ISSUE: Certificate of Appropriateness for alterations, and Waiver of Fence Height.

APPLICANT: William Rydell and Ellen Rydell

LOCATION: Parker-Gray District
220 North Alfred Street

BAR #2022-00172
220 North Alfred Street

Partial Site Plan
and Elevation
BAR Submittal
April 04, 2022

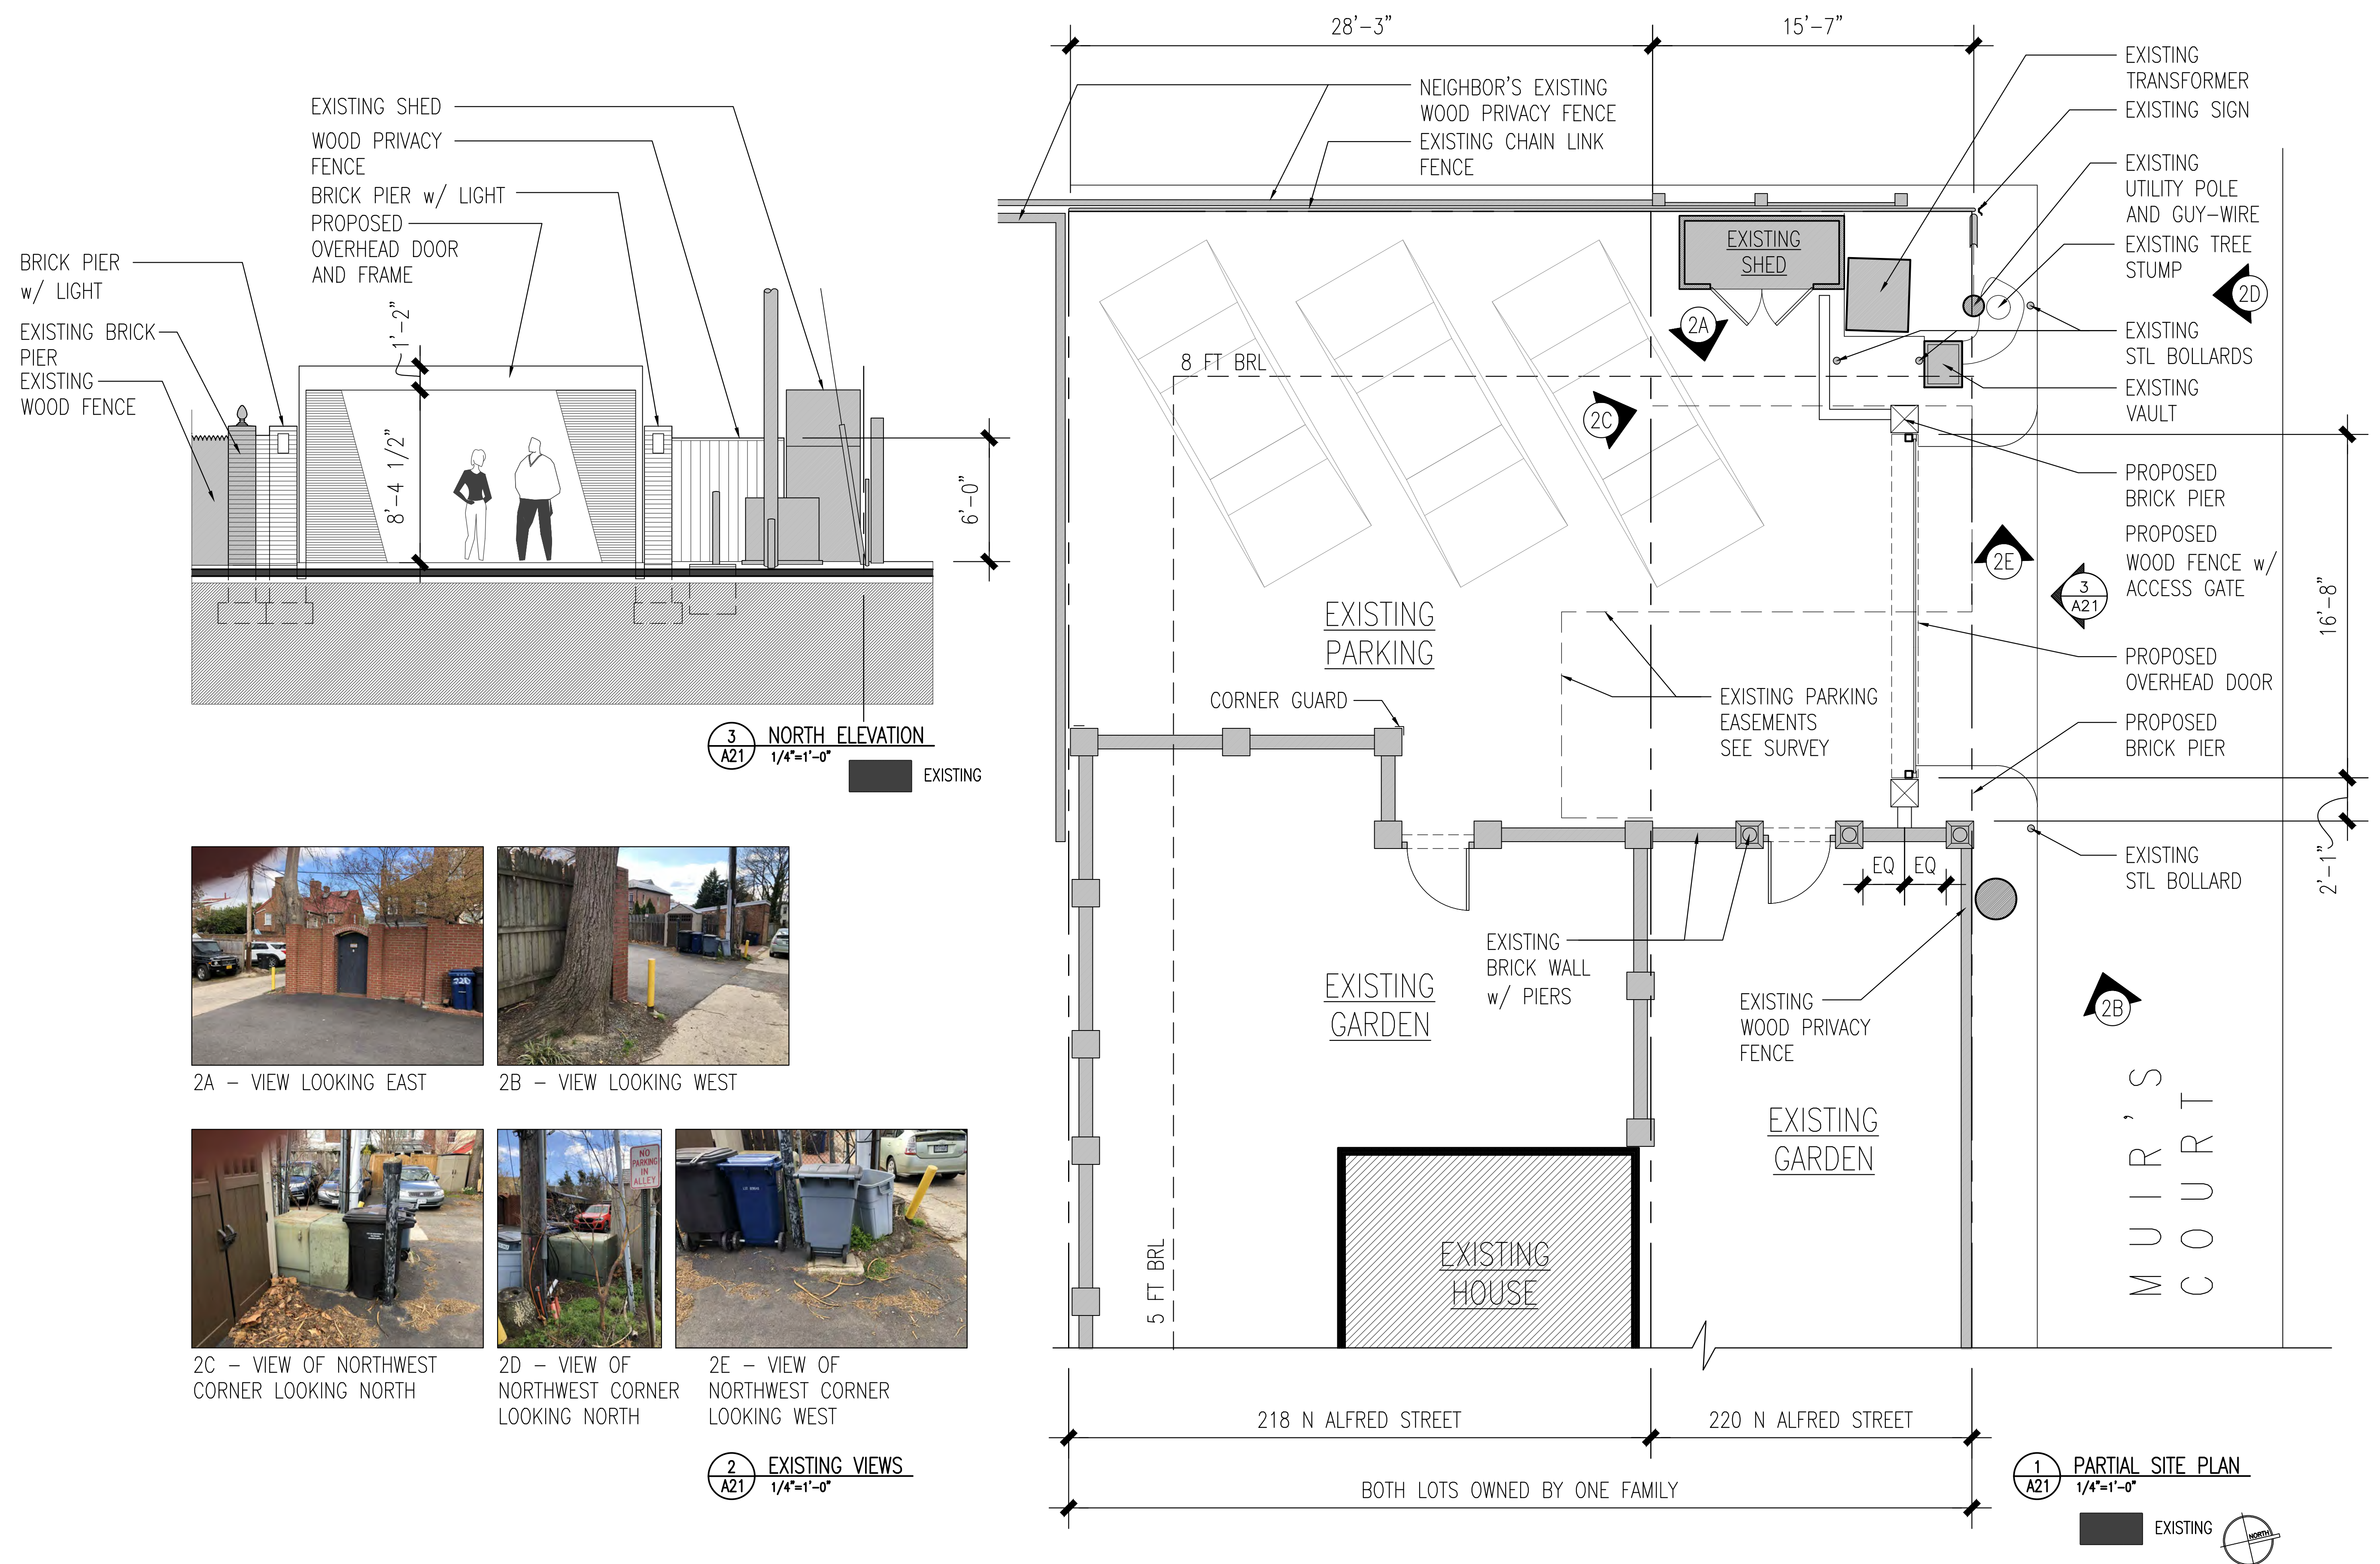
Staff has no objection to the proposed rear fence and supports the waiver of fence height requirement. The *Design Guidelines* state that fences are important visual feature of the historic district that define property lines and provide a sense of privacy and enclosure for property owners. The proposed fence is appropriate in materials, design, and scale for the structure it surrounds. The use of a modern material for the overhead doors differentiates it as a later alteration. Additionally, the proposed fence will be minimally visible from the public right-of-way.

F-1 The proposed overhead garage door is considered to be a fence.

- F-2 The proposed brick piers and overhead garage door exceed 6 feet in height, which is the maximum height allowed for a side yard fence. However, per section 7-202(D), the fence height restrictions may be waived or modified by the Board of Architectural Review where the board finds that a proposed fence would be architecturally appropriate and consistent with the character of the district.
- F-2 The proposed fence that is 6.00 feet in height complies with zoning. If the BAR waives the restriction for fence heights, the brick piers and overhead garage door will also comply with zoning.
